PLANNING & ZONING COMMISSION

RE: **Request for Minor Site Plan; Waterman Early Learning Academy** (Project Name); 1303 Limit Avenue (Address); North of Limit Avenue, east of US Highway 441 (Location); John Stover, Waterman Early Learning Academy (Applicant); David Clutts P.E, Civil Engineering Solutions, Inc. (Engineer); Florida Material Alliance, Inc. (Property Owner); L.R. Huffstetler, Inc. (Landscape Architect); Project No. SP26-06Minor

Subject: Waterman Early Learning / Waterman Christian Academy (Alt Key: 3310306)
Site Plan (SP26-06Minor) – First Review

Excerpt from Landscape Buffer Plan

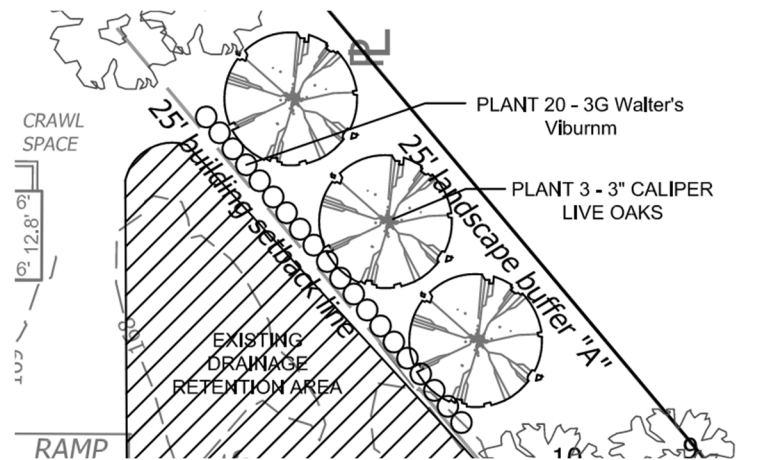
5. The Existing Landscape Buffer document does not show the existing canopy that are greater than six (6) inches in diameter for the northern buffer. A 25-ft landscape buffer "A" shall be provided.

Response: The Landscape Buffer Plan has been updated to show the trees along the northern and eastern property lines. There is one section on the north property line where after a detail inventory was conducted the buffer requires augmentation with 20 – 3 gal Walters Viburnum and 3- 3" Caliper Live Oaks.

Sheet No.:
C5.00

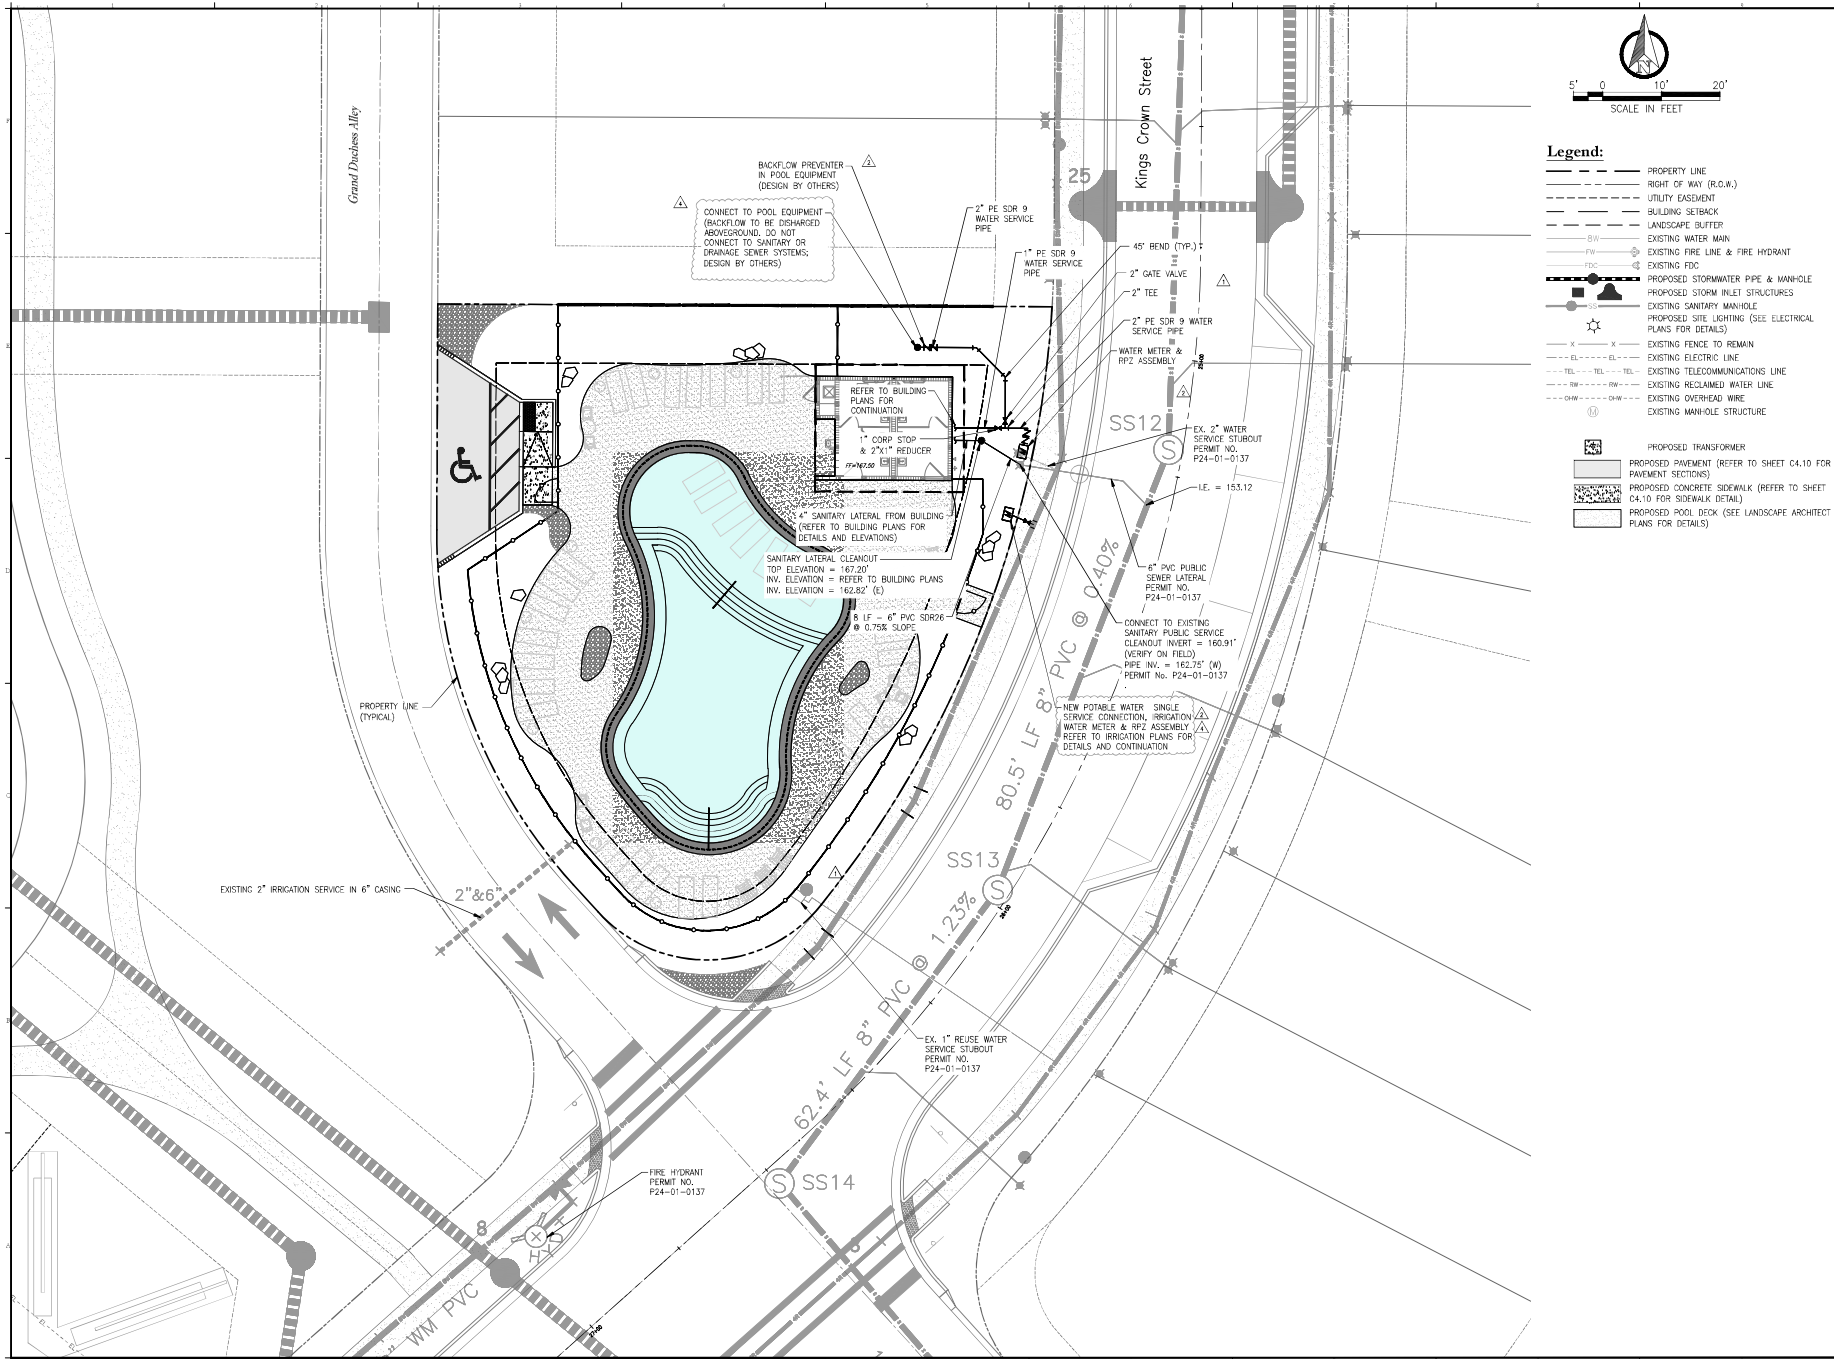
- A. Sheet C5.00 – Please make all proposed utilities black, not light grey.
- B. Revised irrigation plans were not provided with this submittal. The revised plan sheet C5.00 indicates the irrigation service line will be 1-inch (2"x1" TEE call out on plans). The note on the plans also states to see the Irrigation plans for details and continuation.

Response: Sheet C5.00 has been revised to reflect new/separate 1" water service connection for the irrigation system.

Response: Site (Civil) plan sheet C5.00 has been revised to reflect new/separate 1" water service connection for the irrigation system. Irrigation plans refer to civil plans.

Response: Noted. The plans have been revised to remove the connection to the stormwater system. A callout has been added to sheet C5.00 indicating that backflow cannot be connected to sanitary or drainage systems.
